REQUEST

Current Zoning: O-1(CD) (office, conditional)
Proposed Zoning: O-1(CD)SPA (office, conditional, site plan amendment)

Approximately 1.27 acres located on the north side of Ballantyne Commons Parkway, east of Rea Road (Council District 7 - Driggs)

The petition proposes redevelopment the existing single family home and lot with a 24,750-square foot office building and associated parking east of the Stonecrest Shopping Center.

• **Proposed Request Details**

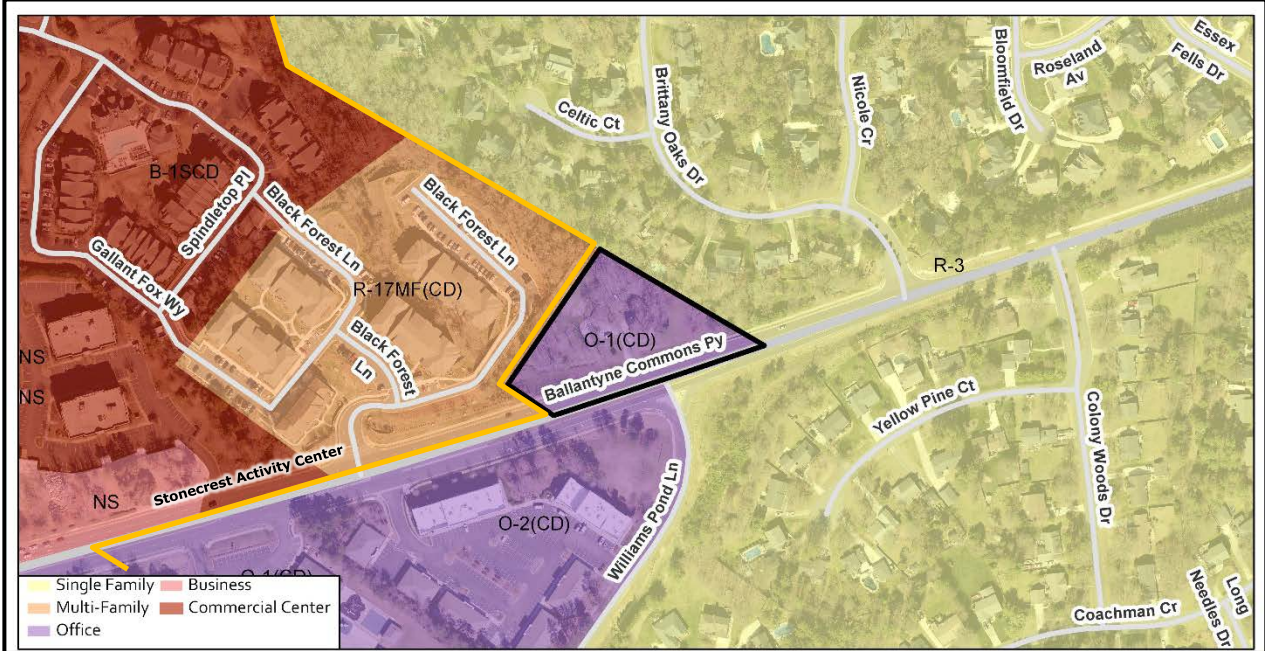
The site plan amendment contains the following changes:

- Allow the demolition of the existing 2,982-square foot structure, a single-family home that was to remain and be used for office through prior rezoning petition 2013-014.

- Proposes the construction of a 24,750-square foot office building with associated over/under parking structure to be built into topography (the upper level of the parking will be at ground level along the northeast side of the site with a second level of parking below ground).

- Provides a 165-foot class C buffer with a ten-foot screen wall along the northeast property line, abutting single family uses. Specifies this buffer will not be reduced. The previous plan required a 16-foot class C buffer that was allowed to be reduced to 12 feet with a fence or wall.

- Provides a Class C buffer along the northwest property line, abutting multi-family uses. This buffer will be reduced as allowed by the Zoning Ordinance.

- Changes the allowed uses from only office uses to office, medical office or financial uses and adds prohibition on accessory drive-through windows.
- Replaces the five-foot wide sidewalk that was previously allowed to remain with an eight-foot planting strip and six-foot sidewalk along the frontage of Ballantyne Commons Parkway.

1. ~~Expand Note 7 under Architectural Guidelines to state that the entry plaza will include pedestrian amenities such as, but not limited to, seating areas, art, water features and/or specialty landscaping.~~ Addressed.

2. ~~Label the storefront entry and clear glass windows on the first floor of the building renderings.~~ Addressed.
3. ~~Amend the buffer and label along the northwest property line to provide a 12-ft wide (16 feet reduced by 25% with the screening fence) Class C buffer, rather than 10 feet as shown on the site plan. In addition, add a note under Streetscape and Landscaping that reads "A 16' Class C buffer along the northwestern property line will be reduced to 12-ft with the provision of a 6' tall screen wall."~~ Addressed.

4. ~~Amend the site plan to show a 16-foot Class C buffer along the northeastern property line rather than a 15-foot buffer. In addition, amend Note 12 to read "The 16' Class C buffer may not be reduced along the northeastern property line. A 6' tall screen wall will be provided along the northeastern property line."~~ Addressed, additionally the petitioner increased the height of the screen wall along the northeast property line to 10 feet.

6. ~~Update the site plan to show two feet of right-of-way behind the sidewalk or show a two-foot easement behind sidewalk.~~ Addressed, added an easement two-feet behind the sidewalk.
